Intel Bay Trail-M Platform Block Diagram

Quanta Computer Inc.
PROJECT : NL6

DOC NO.	PROJECT MODEL : Chrome	APPROVED BY:	DATE:	 Quanta Computer Inc. PROJECT : RL6 Change list
	PART NUMBER:	DRAWING BY:	REVISION:

Model Version CHANGE LIST

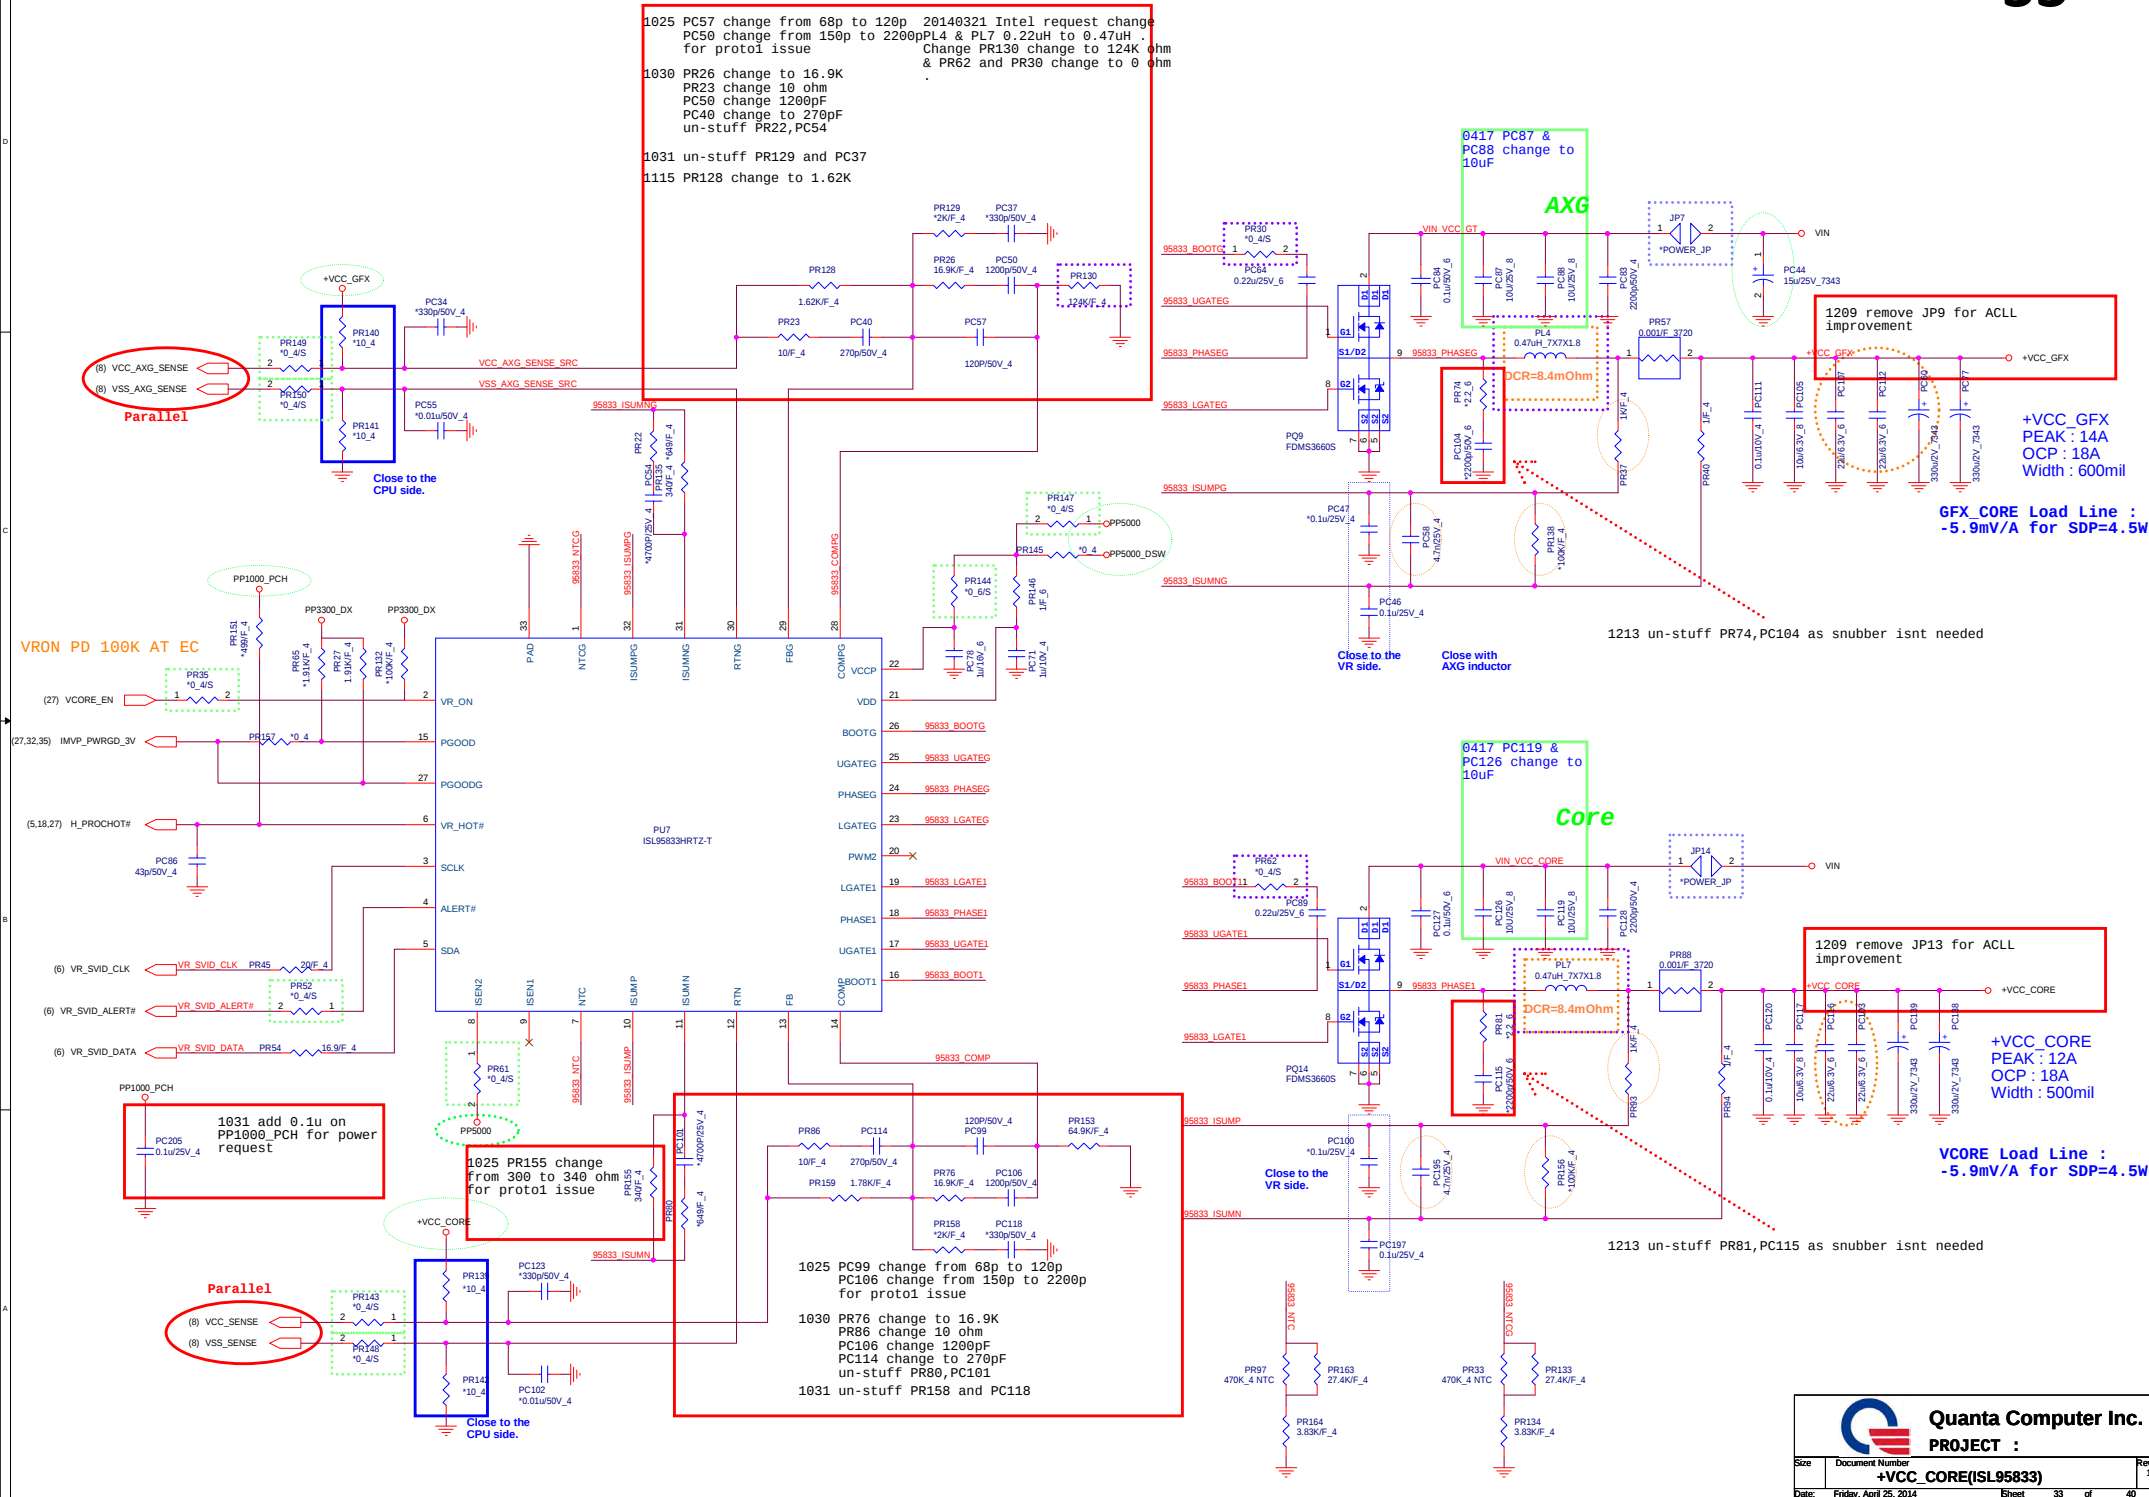
1129 PP1000_PCH changes from convert to power MOSFET type for power efficiency improvement

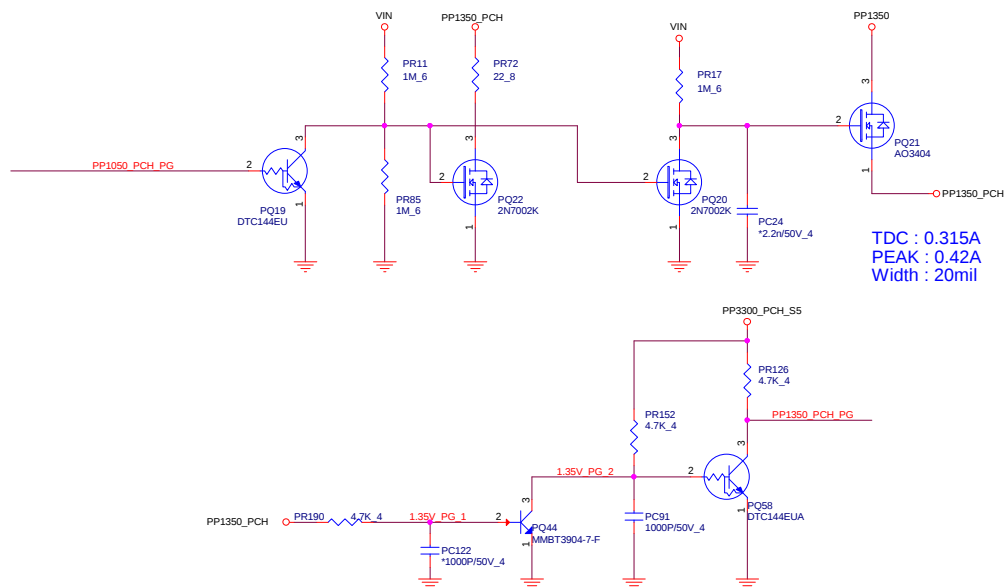
1129 PP1000_PCH_S5 change from LDO to switching power

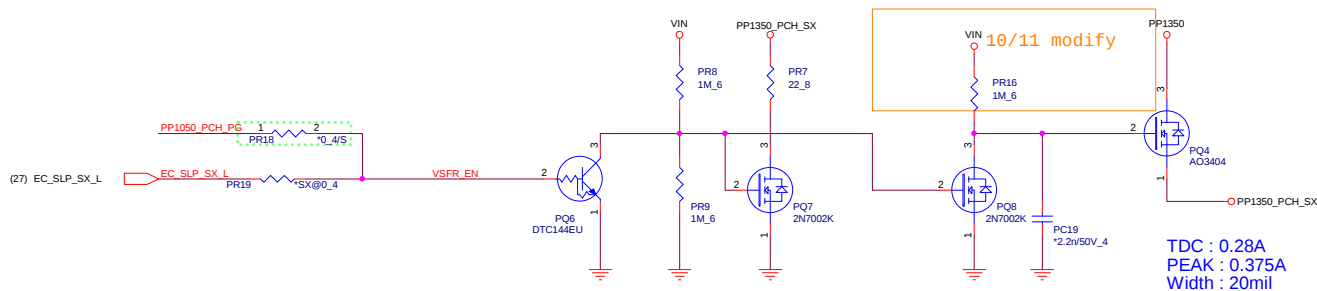
1129 PP1350_PCH change from LDO to power MOSFET
